# Access Compliance Report

## Public Rights-of-Way

Intersection ID: 16629	Main Street: HAVERHILL_DR	Cross Street: SCALEYBARK_RD	Location:	S
ADA ID: 1C6307FA107D	Ramp Type: Combination1Diag	Initial Pass/Fail: Fail	Overall Compliance: No	Severity Score: 0

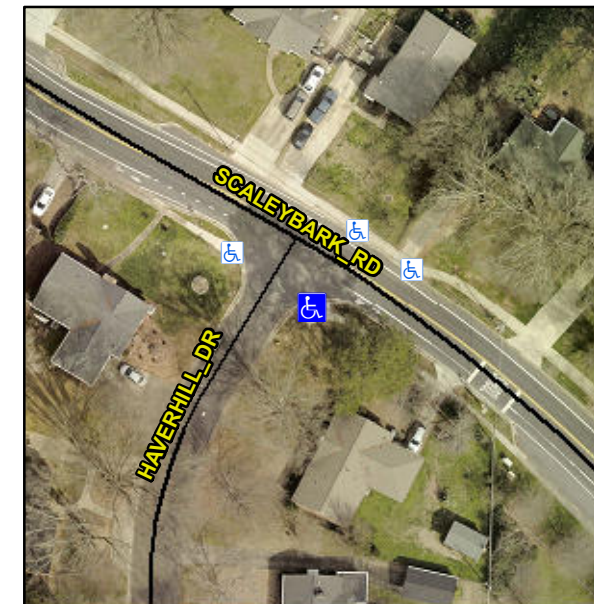
**R304.3.2**

Compliance	Description	Data	Compliance	Description	Data
N/A	Ramp Length LT (in)	51.0	N/A	Ramp Length RT (in)	40.0
Yes	Ramp Width LT (in)	60.0	Yes	Ramp Width RT (in)	59.5
Yes	Ramp Slope LT (%)	6.6	No	Ramp Slope RT (%)	8.9
Yes	Ramp XSlope LT (%)	0.4	Yes	Ramp XSlope RT (%)	0.4
N/A	Ramp Length (in)	61.0	Yes	Ramp Slope (%)	2.2
Yes	Ramp Width (in)	54.0	Yes	Ramp XSlope (%)	1.4
N/A	Flare Type LT	N/A	N/A	Flare Type RT	N/A
N/A	Flare Slope LT (%)	N/A	N/A	Flare Slope RT (%)	N/A
N/A	Flare Traversable LT?	N/A	N/A	Flare Traversable RT?	N/A
N/A	Landing Length (in)	N/A	N/A	DWS Provided?	N/A
N/A	Landing Width (in)	N/A	N/A	DWS Contrast?	N/A
N/A	Landing Slope (%)	N/A	N/A	DWS Length (in)	N/A
N/A	Landing X Slope (%)	N/A	N/A	DWS Full Width?	N/A
N/A	Landing Curb? (Y/N)	N/A	N/A	DWS Offset (in)	N/A
N/A	Shared Landing?	N/A			
N/A	Gutter Ponding?	N/A	N/A	Gutter Slope (%)	N/A
N/A	Gutter Lip Ht (in)	N/A	N/A	Gutter X Slope (%)	N/A
N/A	Painted X Walk1?	No	N/A	Painted X Walk2?	No

**Remove & Replace Curb Ramp With Two New Directional Ramps or Equivalent.**
